## 工程指示 / 要求簡箋(E.I.)

工程指示編號 : EI / 5706 / 23

工程編號 : J - 858

工程名稱 : 將軍澳日出康城 11

# J858单元幕墙胶条位置图

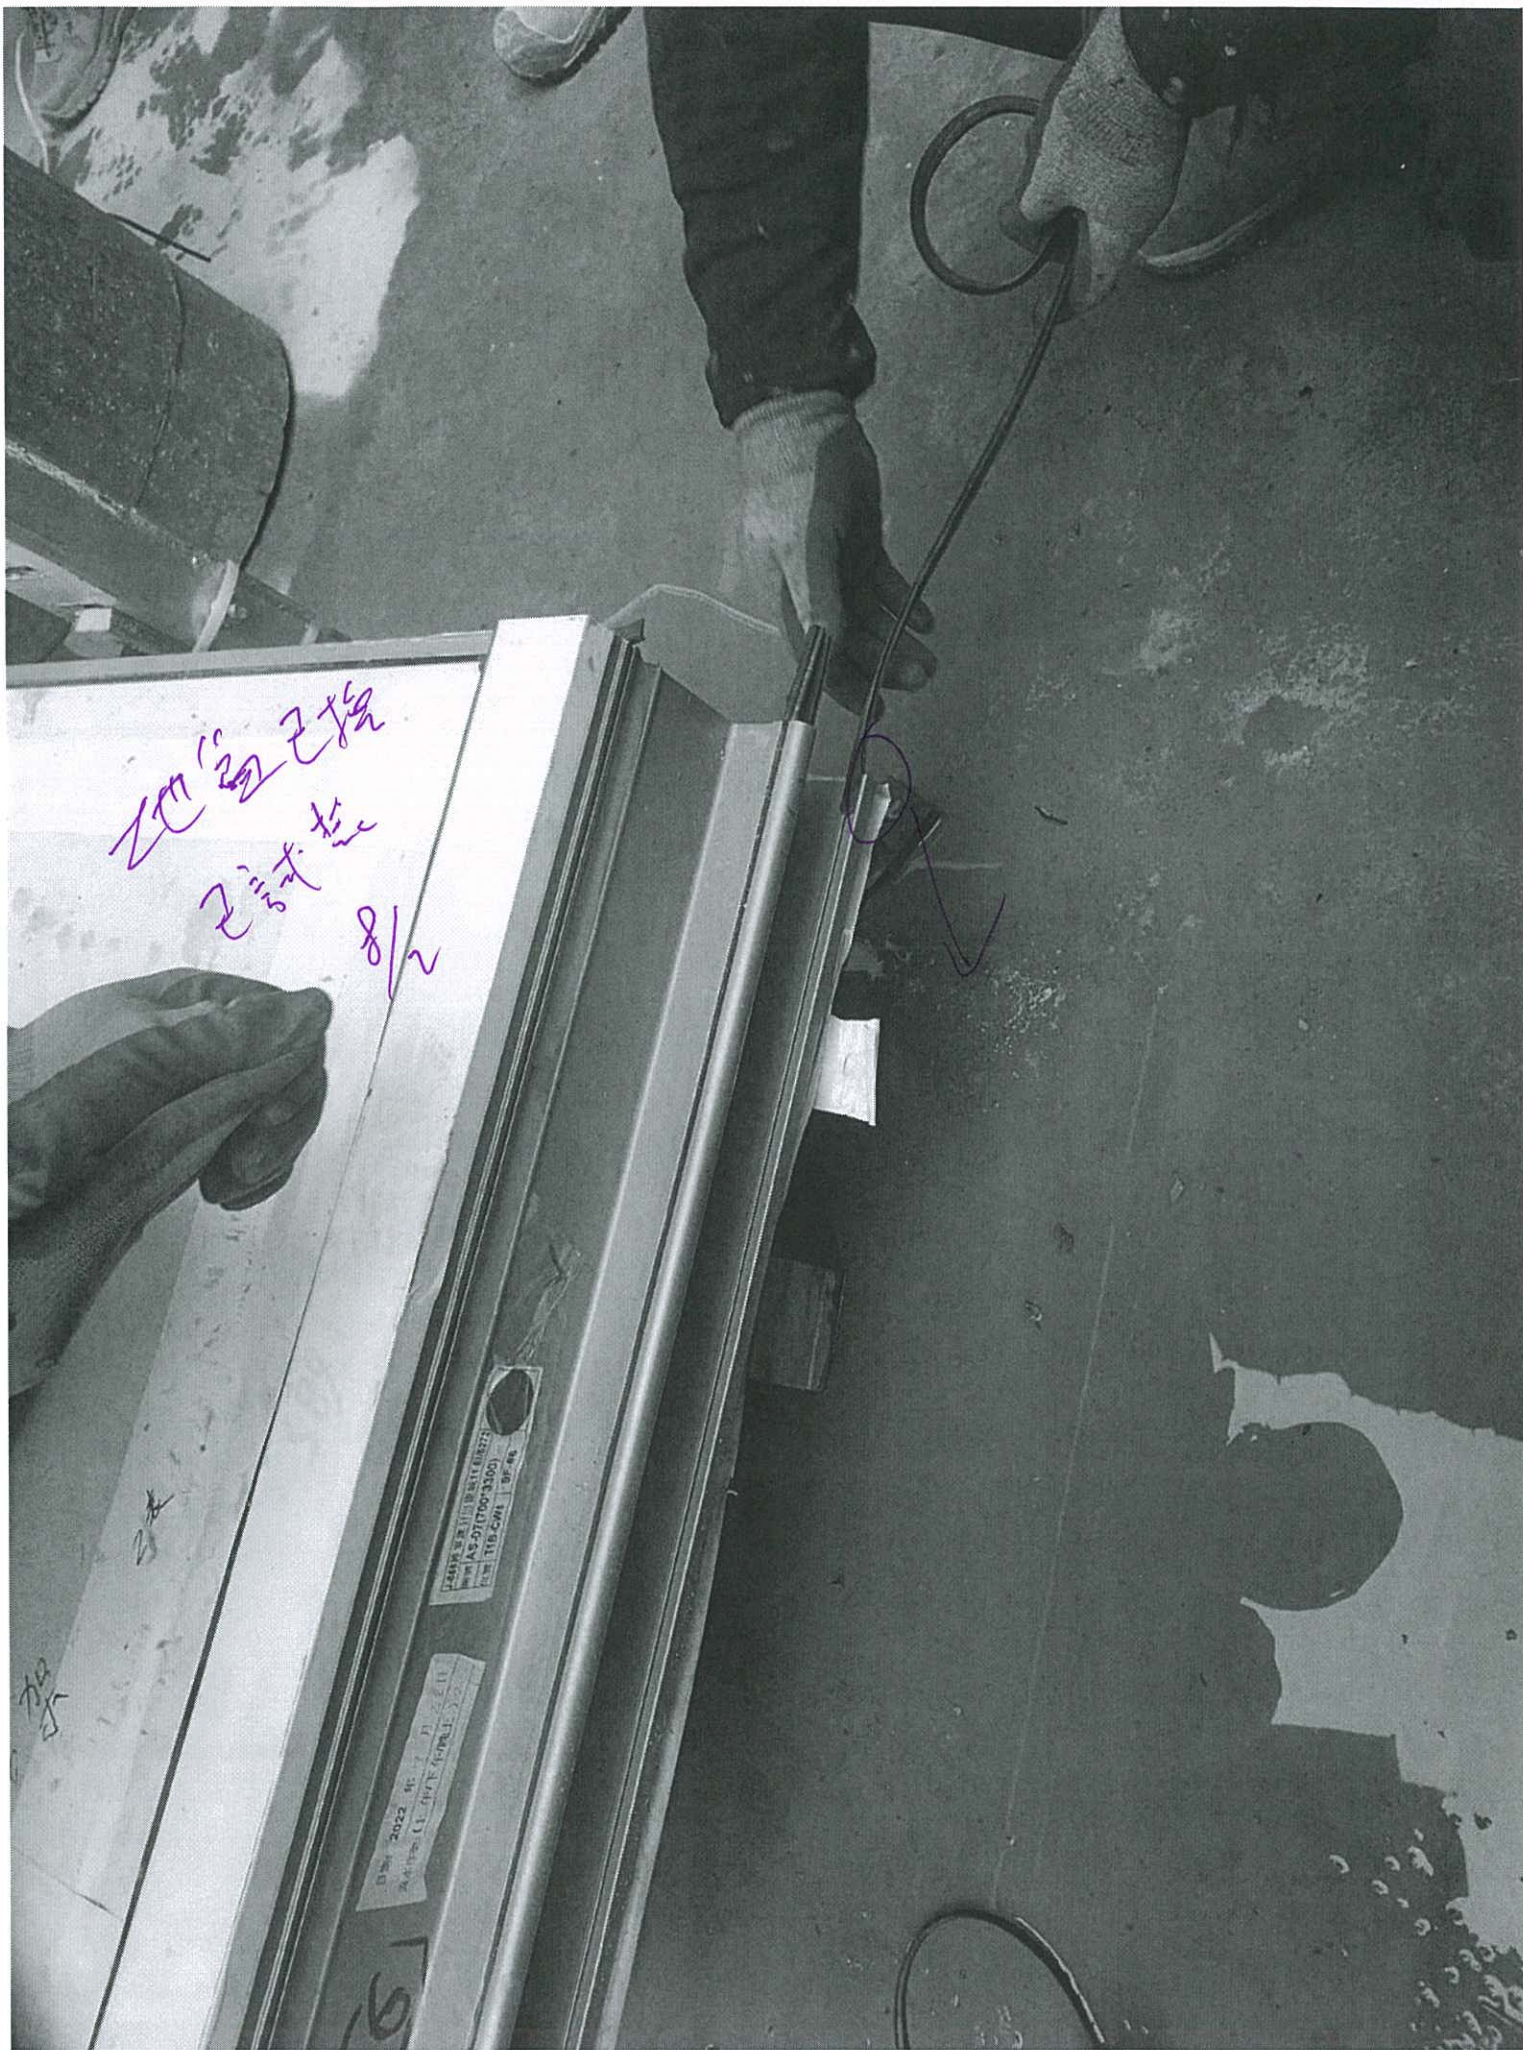
因應地盆顧問現場 comment。地盆已試裝, 水槽料靠室內, 需使用 Jt10。拆圖部, : 請修改鋁料加工圖和膠條位置圖。生統: 請留意水槽料靠室內, 須需使用 Jt10。請在 2023.02.11 前完成上列要求。
